Item Name: Replacement Skidtube (Fits LH or RH)

DRAWING NO. D2650	TITLE 206/407 SKIDTUBE ASSEMBLIES	REV. F	DART AEROSPACE LTD ENGINEERING ORDER		D.E.O. NO. D2650-F-1	SHEET NO. SHEET 1 OF 1	SCALE NTS
DRAWN <i>JP</i>	CHECKED <i>A.P.</i>	MFG. APPR. <i>AA</i>	APPROVED <i>##</i>		DE APPR. <i>##</i>		
DATE 12.10.12	DATE 12.10.22	DATE 12.10.22	DATE 12.10.22		DATE 12.10.22

CHANGE C'BORED WELDED CROSSBOLT SPACERS TO SWAGED SPACERS

AMENDMENT TO DETAIL B
NOT TO SCALE

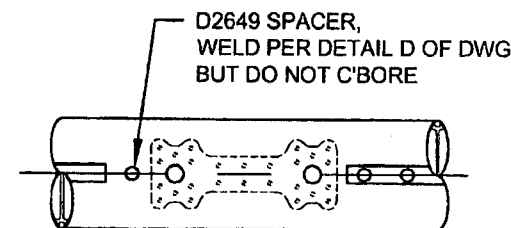
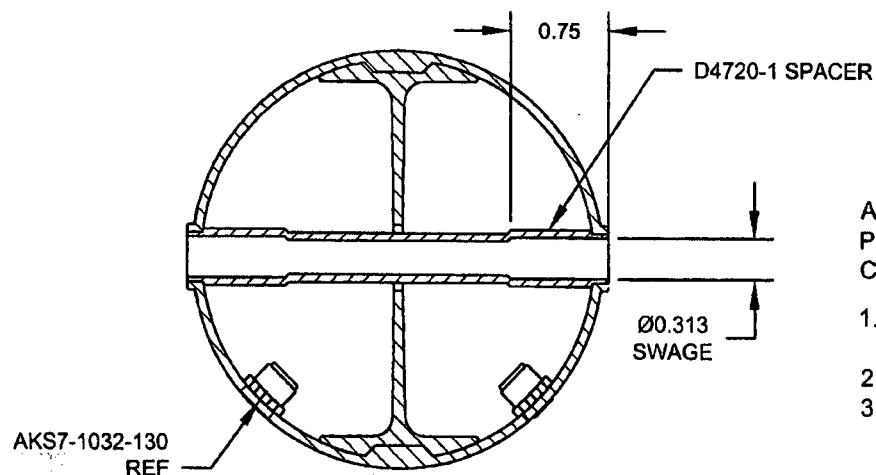
ADD DETAIL G BELOW, WHICH IS THE SAME SECTION VIEW AS DETAIL D OF DWG.

C'BORED HOLES ARE **NOW SWAGED** PER DETAIL G BELOW. FOR THE Ø0.375 HOLE THAT IS NOT C'BORED, WELD PER DETAIL D OF DWG (SEE AMENDED DETAIL B FOR REFERENCE).

FOR Ø0.375 HOLES ONLY
FOR HOLES THAT ARE CURRENTLY C'BORED ONLY
NOT TO SCALE

AFTER DRILLING AND BENDING ASSEMBLY
PERFORM THE FOLLOWING FOR Ø0.375 HOLES THAT ARE
CURRENTLY C'BORED:

1. INSERT D4720-1 SPACER, 16 PL (-1) OR 17 PL (-3)
OR 19 PL (-5) OR 23 PL (-7)
2. SWAGE TO Ø0.313 X 0.75 DP PER QSI 002
3. TRIM / GRIND FLUSH PER QSI 002
